PREVOST

Warranty Bulletin

96-18

Date: **October 1996**
Section: **06**
Subject: **BOOSTER POST POWER CABLE INSPECTION**
Application:

FIGURE 1: CABLE LOCATION

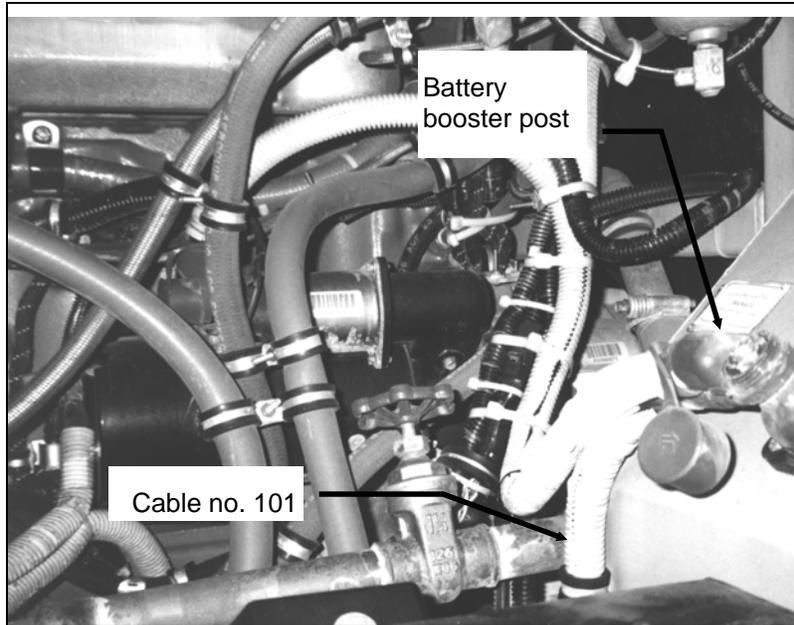
On the above-mentioned vehicles, the main power cable which brings power from the cut-out switch to the battery booster post in the engine bay could use prematurely due to friction. Friction of this cable on the vehicle structure or any mechanical components could cause a fire in the engine compartment. It is paramount that your vehicle be inspected and corrective actions be taken, if required, to properly secure the cable as explained herein. There are three sections (or tasks) in this bulletin. Depending on the condition of the cable on your vehicle, you are requested to complete section A (mandatory), and possibly section B or C (depending on cable condition). **Note that this is a SAFETY RECALL CAMPAIGN.**

1. In the engine compartment, locate cable 101A (Fig. 1).
2. Inspect cable for any damages caused by friction on sharp or abrasive objects. Pay particular attention to the section of the cable which is routed close to the engine cradle leg. Figure 2 shows the particularly sharp edges of the cradle leg where abrasion could occur.

3. If cable is slightly damaged (i.e. insulation of cable slightly cut and/or ground) go directly to **Section B**.
4. If cable is no longer useable (i.e. copper inside cable is cut and/or burnt) go directly to **Section C**.
5. Move cable with your hand and make sure that:
 - a. cable does not rub on any sharp or abrasive objects.
 - b. cable does not get closer than 2" (5 cm) to any sharp or abrasive objects.

-
- If cable rubs on a sharp or abrasive object or if it gets within 2" (5 cm) of one, secure cable with cable ties (Prevost #504016) to prevent premature damage to cable.

FIGURE 3

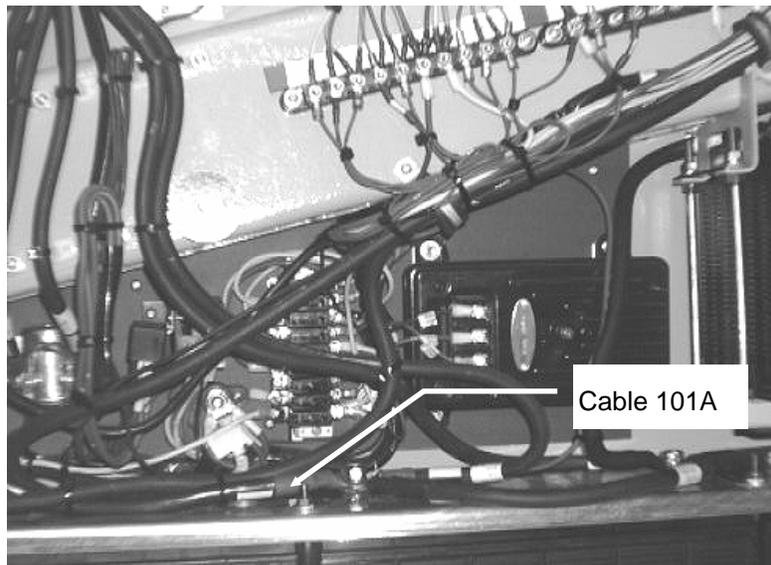
3. Disconnect cable no. 101A from battery (Fig. 3).

20. In the battery compartment, reconnect cable no.101A to battery (Fig. 3) and torque nut at 10-15 lbf•ft (13-20 N•m).
21. Reconnect battery ground cables.

FIGURE 4

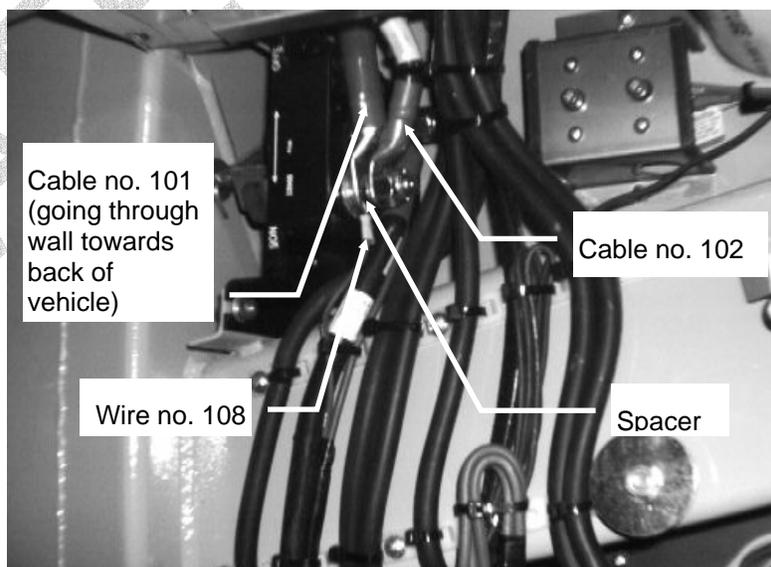
4. In the battery compartment, remove nut, spacer, cable no. 101, cable no. 102 and wire no. 108 from the cut-out switch (Fig. 4).
5. Temporarily reinstall wire no. 108, spacer, cable no. 102 and the nut (tight by hand only) to the cut-out switch. At this point, cable no. 101 (cable going through the wall towards the back of vehicle) should be disconnected.

13. Remove nut, cable no. 102, spacer and wire no. 108 from cut-out switch (Fig. 4).
14. Reinstall in following order: cable no. 101, wire no. 108, spacer, cable no. 102 and nut.
